**STAFF REPORT
PLANNING DIRECTOR DECISION**

FILE NO.: DR-12-13

REQUEST: Class I Design Review for the addition of a drive through/menu aisle at the McDonalds located at 2100 Eighth Court, relocation of garbage and new recycling enclosure, elimination of 12 parking spaces, installation of menu board signage and new landscaping.

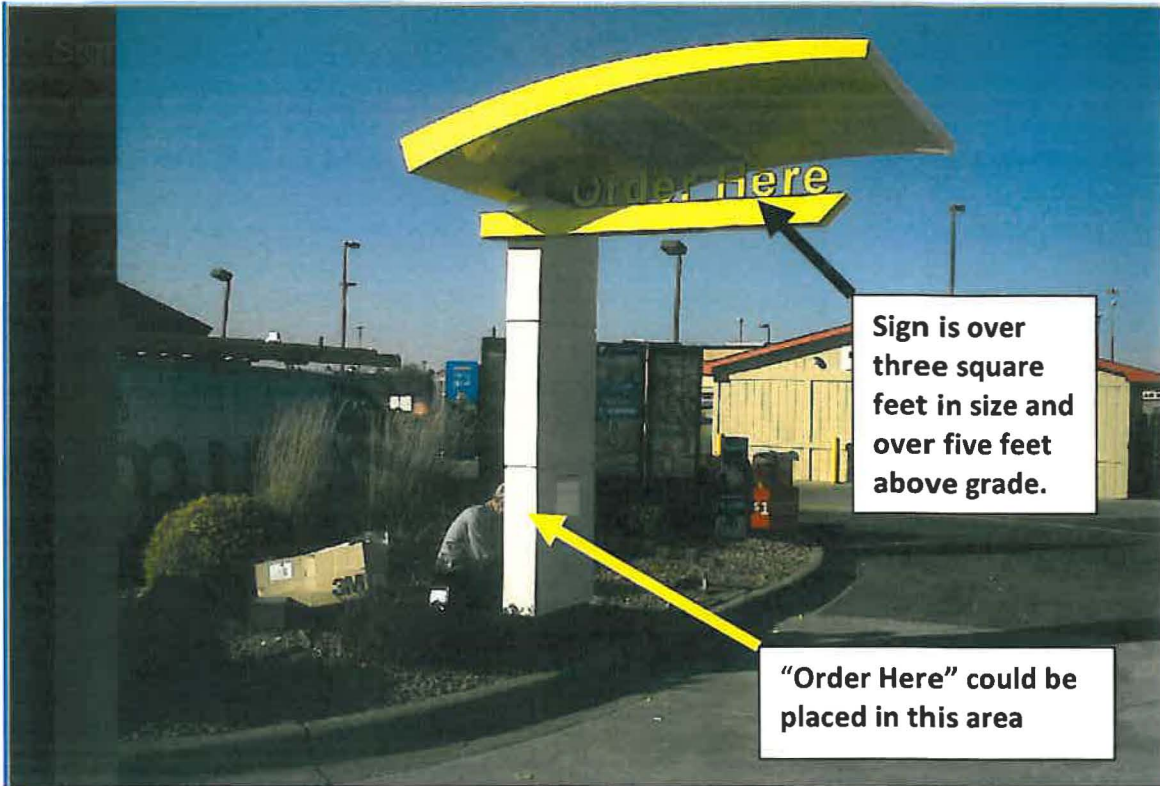
In agreement with footnote 2, above, which states that “²Restaurants with drive-through or take-out windows may have an additional 32 square feet,” the applicant proposes two 31.1 square foot menu boards. The Planning Director has interpreted the highlighted code language above to allow 32 square feet per drive through lane which means that the applicant may have the two menu boards (one for each drive through lane) as proposed.

The applicant also proposes three other signs. Two would state “Order Here” and be placed on a canopy assembly that overhangs the menu board sign; a third would be part of an overhead frame that states “Drive Through” and has a height warning. All are over nine feet high.

Section 52.109(C) allows any number of parking lot or directional signs so long as they do not exceed three square feet each and are not more than five feet above grade. The proposed "Order Here" and "Drive Through" signs all exceed the height standard and dimensional standard and therefore cannot be allowed.

PROJECT TITLE TRASH ENCLOSURE	PROJECT ADDRESS 2100 6TH COURT NEST LANE, OR 97060	STATE CITY CODE OR-97060	SHEET NO. SP5

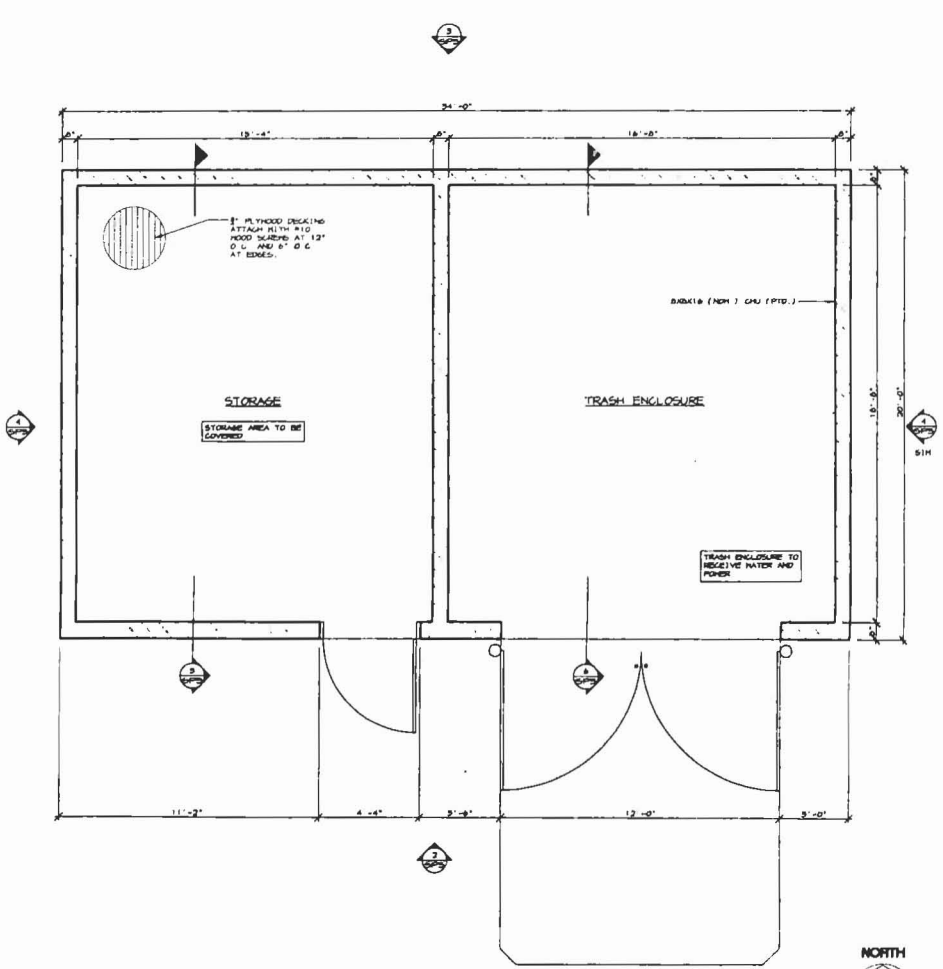
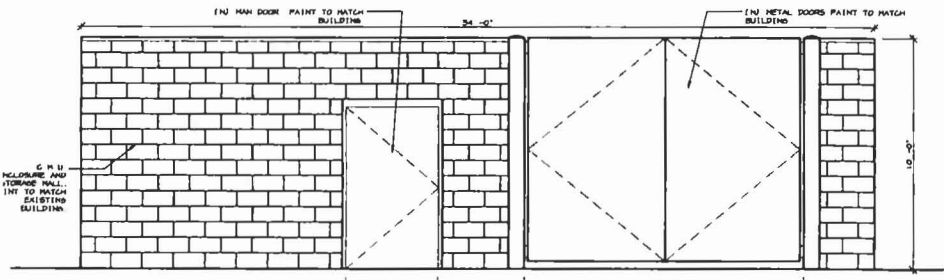
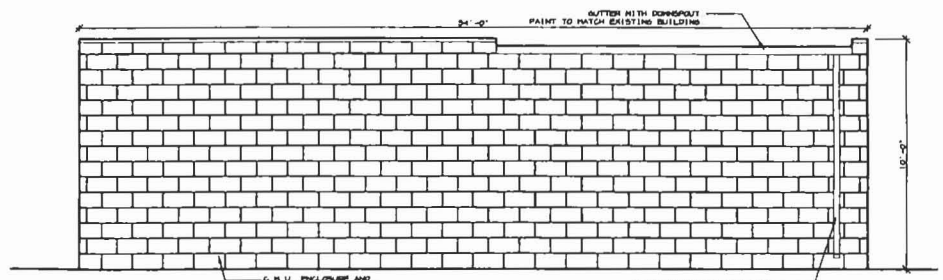
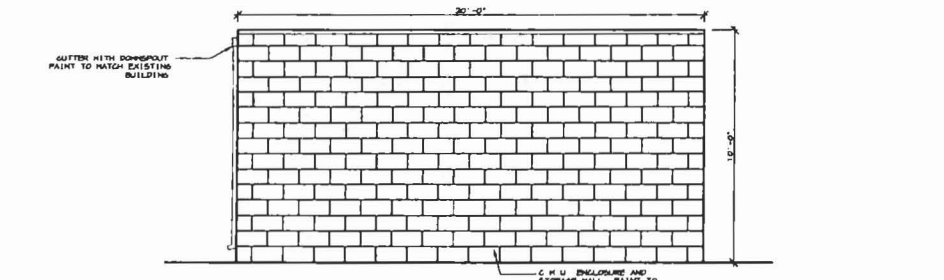
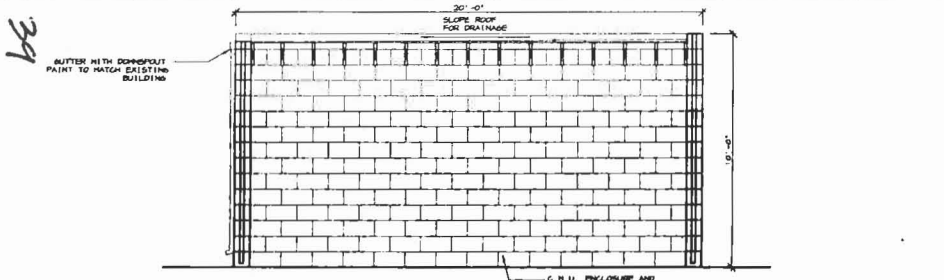
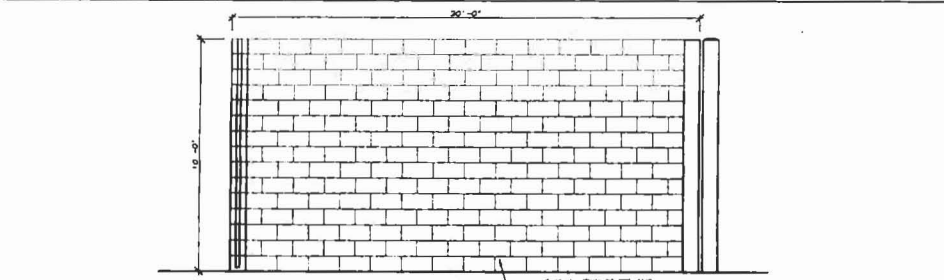
3. *The approval criterion is identified in Section 55.090. You need to provide responses to 55.090(A) (2) and (3). For 55.090(A) (3), the applicant shall address the parking and access standards of 46.150(F), 46.150(9), 46.150(21), 48.040(A) (4). The landscaping standards of 54.020(E) must be met. The recycling and waste disposal standards of 55.100(I) (5) and 55.100(O) must be responded to.*

Response: See Sheet SP1 for the new location and Sheet SP5 for the trash enclosure design.

Response: The building exterior is not part of the scope of work. See Sheet SP1 for parking and trash enclosure location. See Sheet SP5 for trash enclosure details. See Sheet LS1 , for the landscaping plan.

LANDSCAPE PLAN
1" = 20'-0"

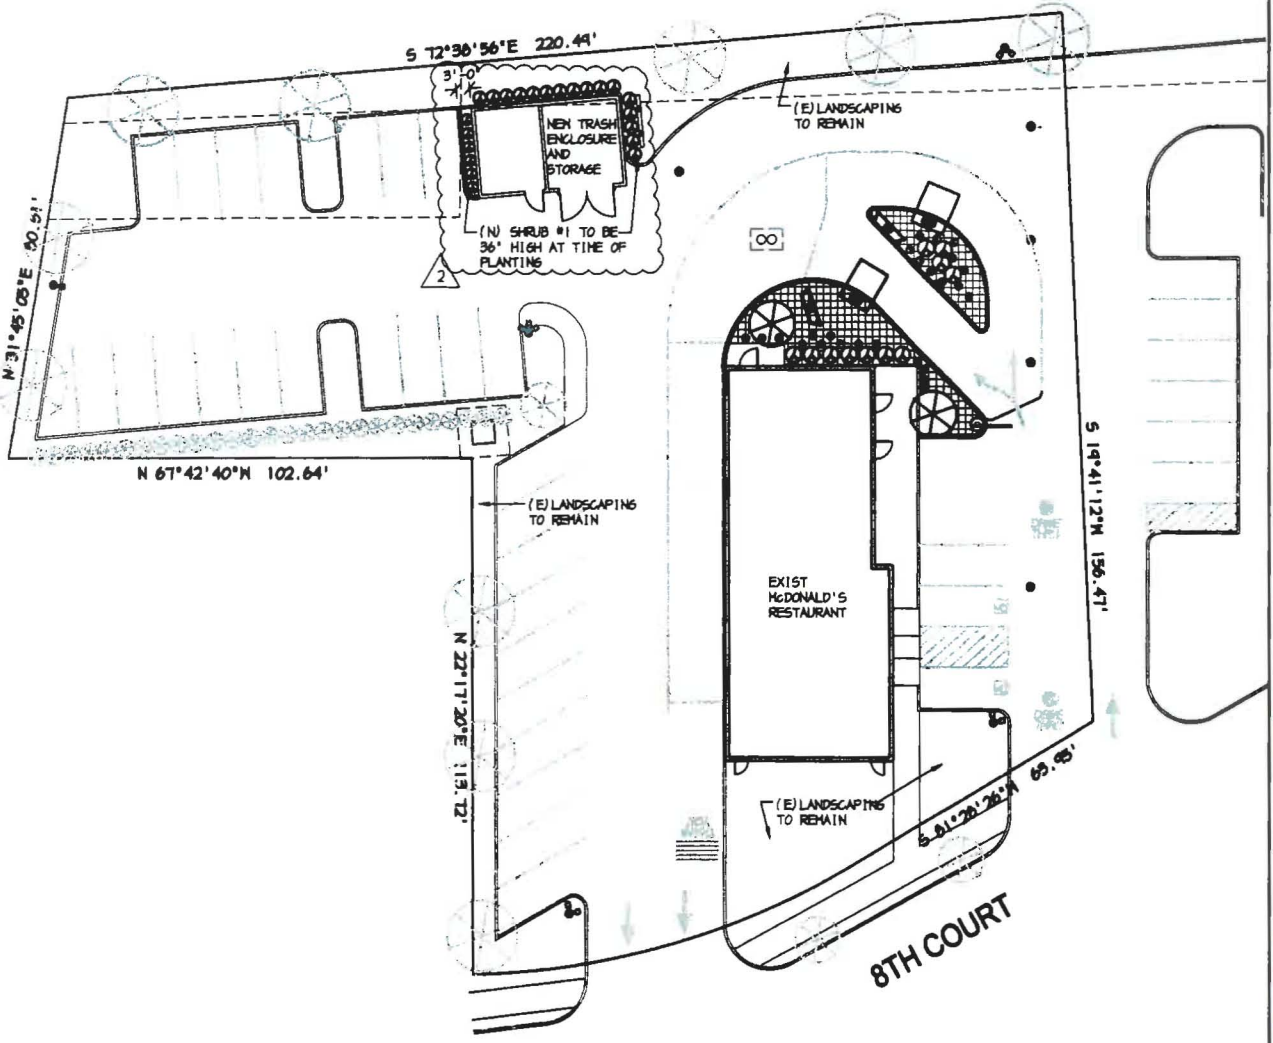
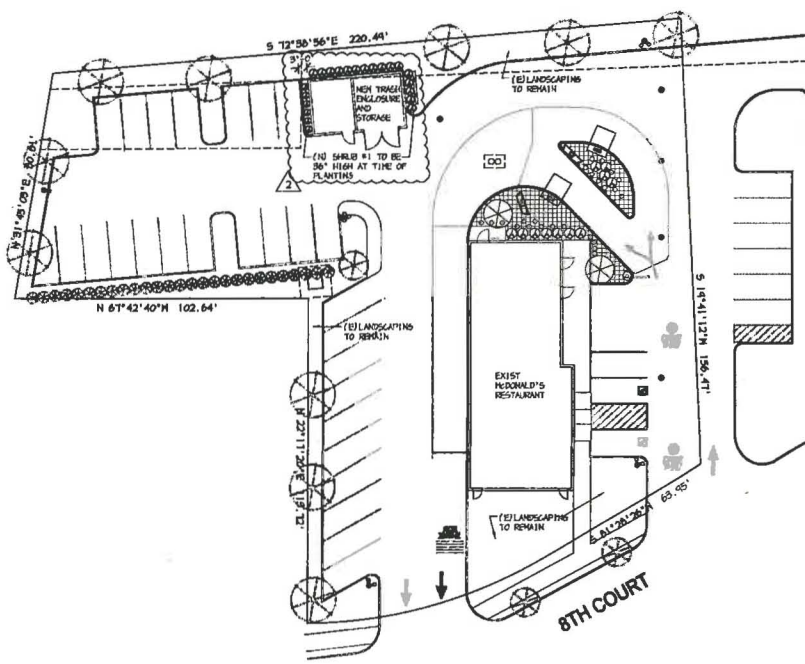
3. *Landscaping: Landscaping will be modified near the menu boards and in the proposed island. There will be no net loss of landscaping square footage. A new landscape plan is required to meet Chapter 52 standards.*

2. *Specifically, the Class I Design Review requires a full and complete response to the submittal requirements per CDC 55.070((D) (1), E-F), (no site analysis is required). Because the landscape area is being modified, you will need to submit a new landscape plan per 55.150. You should also state in the submittal that you want to get approval for the signs. (Alternately you could apply for the sign permits separately or at a later date.)*

Response: The landscaped area will increase from 7,385 SF to 7,615 SF. The Site Area is 33,058 SF, which will put the landscaping percentage to 23%. See Site Data on Sheet SP1 and Sheet L1.

Response: A new landscape plan has been included. We want to get approval for the signs with this submittal.
